CONSERVATION TEAM CONSULTATION APPLICATION RESPONSE

APPLICATION REF:	25/01581/FPH & 25/01582/LBC
CASE OFFICER:	VW
APPLICATION SITE:	188 Park Lane, Old Knebworth, Knebworth, Hertfordshire SG3 6PS
DESCRIPTION OF WORKS:	Replacement rear French doors. Single storey extension to existing detached garden room to facilitate office space. Replacement rear French doors and internal alterations.

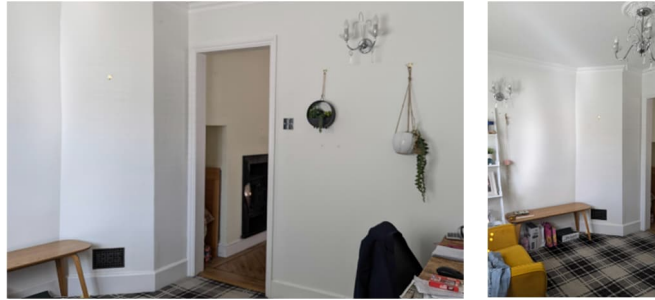
I previously raised a concern regarding the proposed side lights to the rear glazed doors stating that *"had it not been for the fact that the host building is Lutyens-designed I may have been slightly less concerned with the proposed sidelights, but it is important that alterations / additions are sympathetic and maintain the quality of Lutyens' work"*. I went on to say that *"although the proposal will not result in the loss of historic fabric, the opening-up of this aperture with wide sidelights will, in my opinion, have a mildly erosive impact on the listed building. A far better arrangement and a good compromise that would allow more natural light, would be to reinstate French doors with glazing bars and perhaps narrower, half-height sidelights with window sills"*.

As noted below the rear elevation has been amended and the fenestration is a considerable improvement and more respectful of the host building's significance and is acceptable.

The only issue this raises is how this will be implemented. Only yesterday, I offered my comments on a proposal next door at no.190 under refs: 25/01892/FPH & 25/01893/LBC for 'Replacement of 9 existing timber frame windows with double glazed white flush timber casements'. I have raised an objection to that scheme on the basis that replacement Anglian Windows with their 28mm double-glazing system and applied glazing bars with a spacer between and where the internal profile does not match the existing windows, will fail to respect the listed building's special character. It is important that the applicant at no.188 is fully aware of the specification sought i.e. slimlite glazing with 'through' glazing bars and this will need to be conditioned.

3. Joinery section details of the replacement French doors and side lights including 1:1 section detail of the proposed glazing system and glazing bars shall be submitted to and approved in writing by the Local Planning Authority prior to the manufacture of the doors and side lights. Thereafter the doors and side lights shall be installed in accordance with the approved details.
